CONSERVATION COMMISSION AGENDA

The Conservation Commission will hold this meeting as a virtual meeting on Thursday, October 29, 2020 at 7:00 pm. No in-person meeting will take place at City Hall.

2. 41 Concord Street (Leo J Martin Golf Course) – OOC – irrigation and snowmaking upgrades – DEP File #239-877

TENTH HOLE LAGOON PLAN VIEW - DEMOLITION

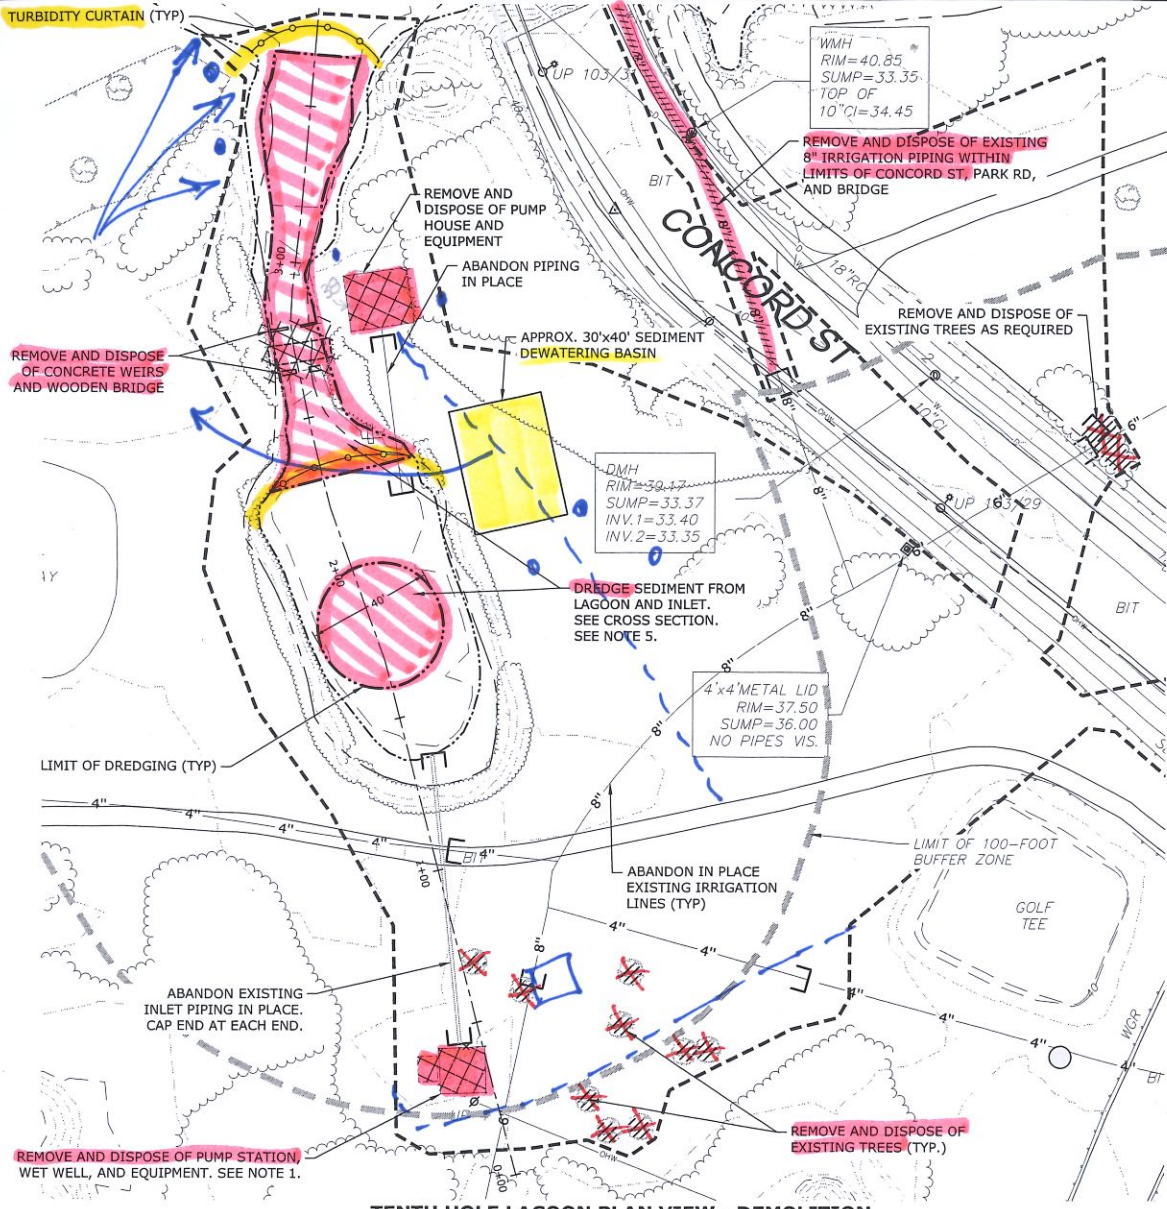
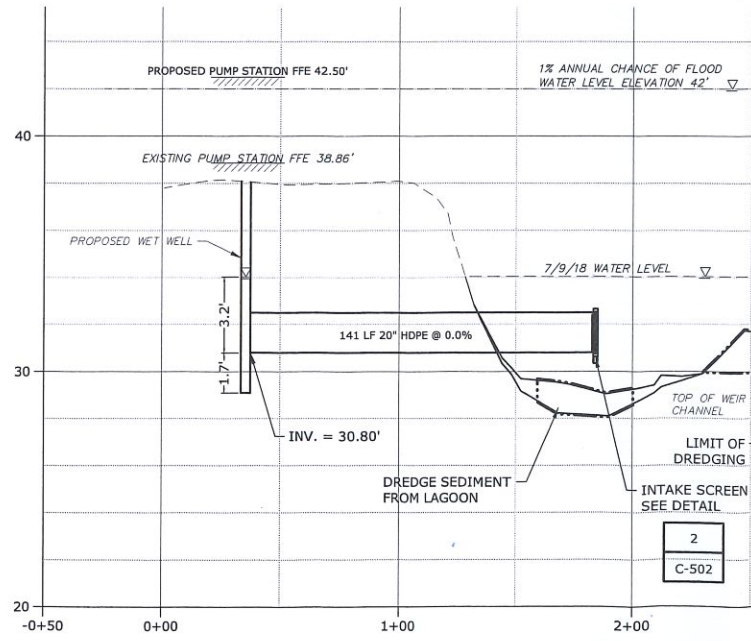
- The applicant should clarify the total area of the lagoon and the total area of dredging. Both 2900 sf and 4530 sf are used in the application.

- Currently the banks of the lagoon are fully vegetated and stable. The applicant should clarify whether (and how) every effort will be made to protect the banks of the lagoon during dredging. The details indicate bank restoration with fill and willow whips in the event of disturbance.

- It appeared to staff, that the location of the proposed pump house and new irrigation lines could be modified to reduce the proposed removal of mature trees. Staff asked the applicant to revise the plans.

- It appeared to staff that access for dredging the lagoon could be better achieved from the western side of the lagoon, with less damage to trees along the bank. Staff asked the applicant to revise the plans showing the new access routes and appropriate protections (such as plywood to protect tree roots).

- o **Staff Recommendations:** Continue the hearing to allow the applicant time to submit revised plans and schedule another site visit with Conservation staff.

TENTH HOLE LAGOON PLAN VIEW - PROPOSED
1"=30'

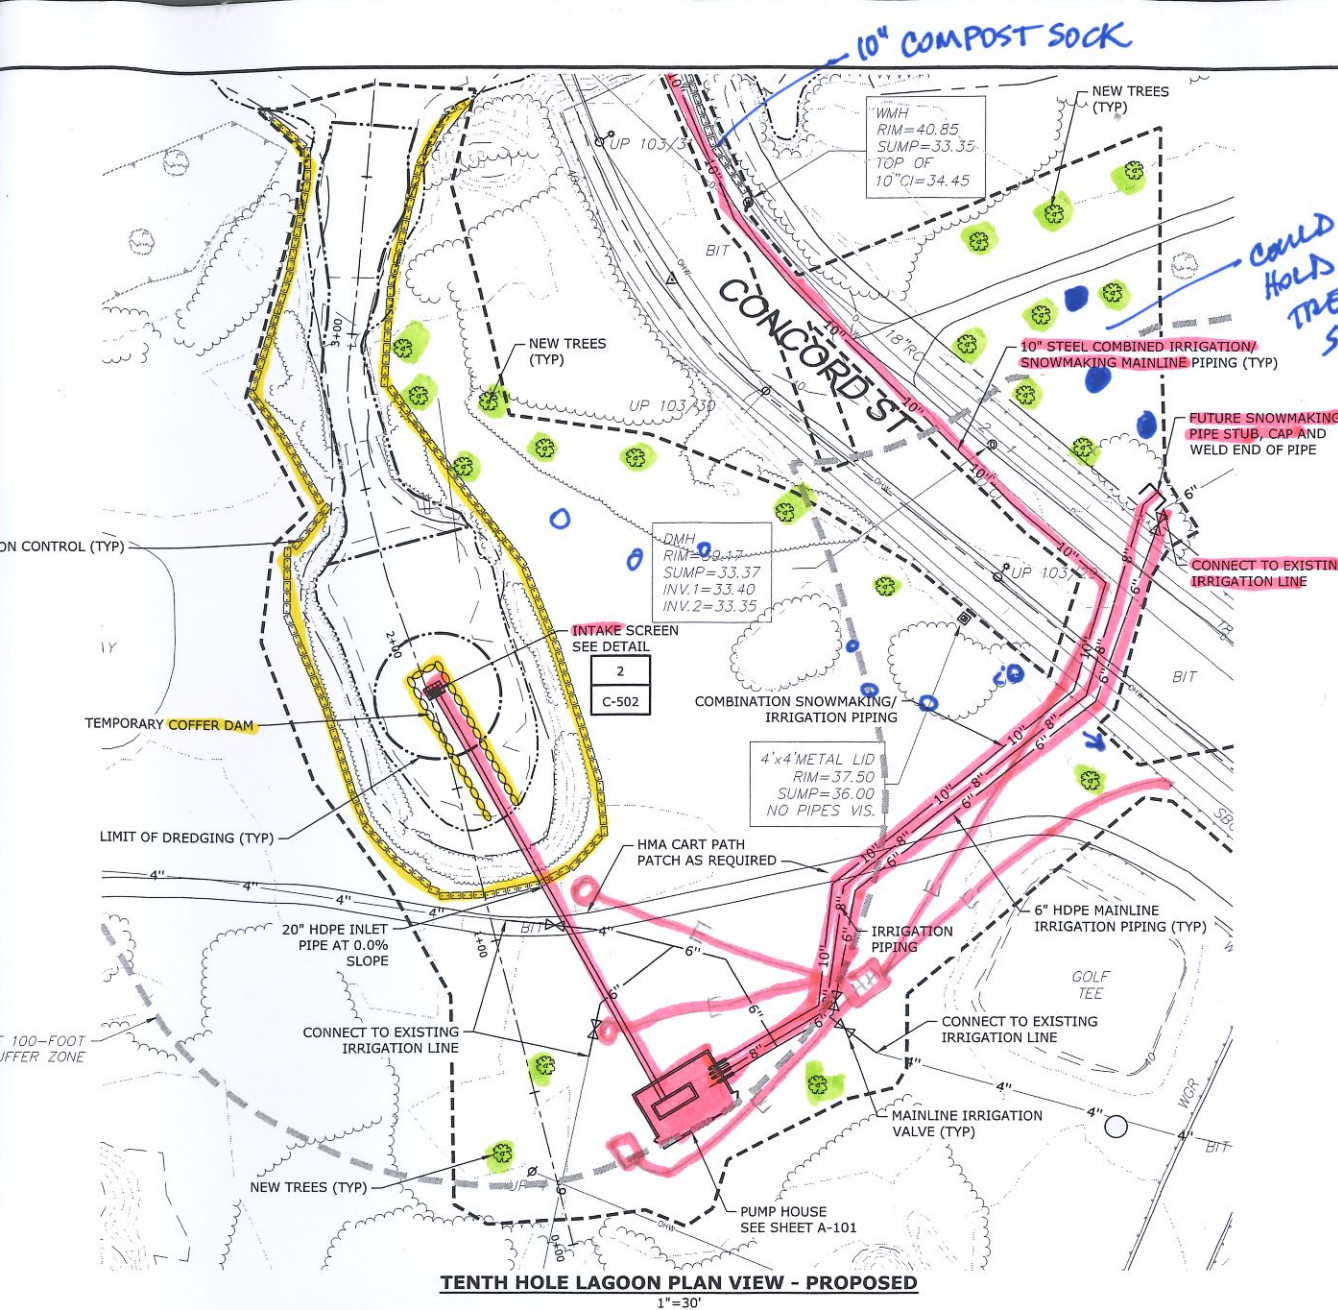
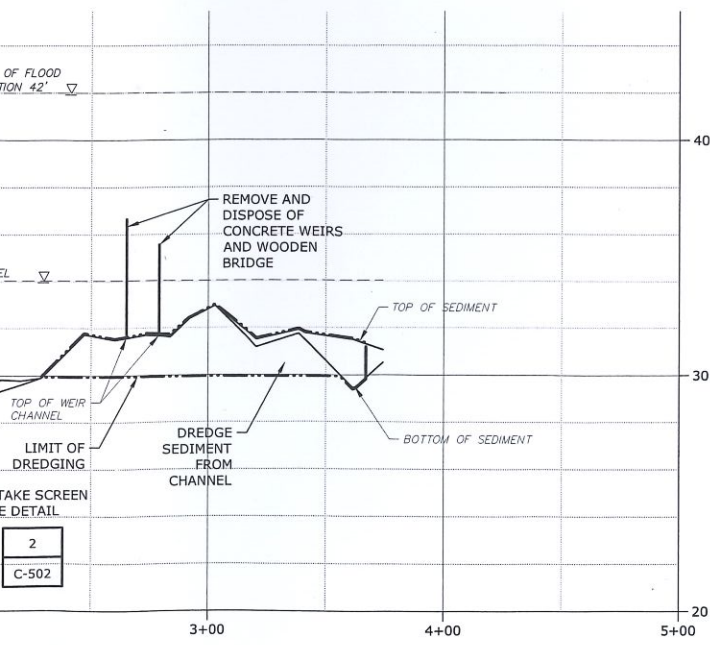
- Staff questioned the stated reason for such extensive tree removal (protection of the pump house). Proactive cutting of huge native trees because of their proximity to a pump house is not warranted under the Act.

- The proposal calls for 234 caliper inches of mature oaks and maples to be removed and only 20 4-6 foot tall saplings to be planted. That seemed to staff wholly inadequate.

- On the site visit, staff noted several areas where enhanced mitigation planting of trees and shrubs could occur. The applicant agreed to enhance the mitigation planting plan.
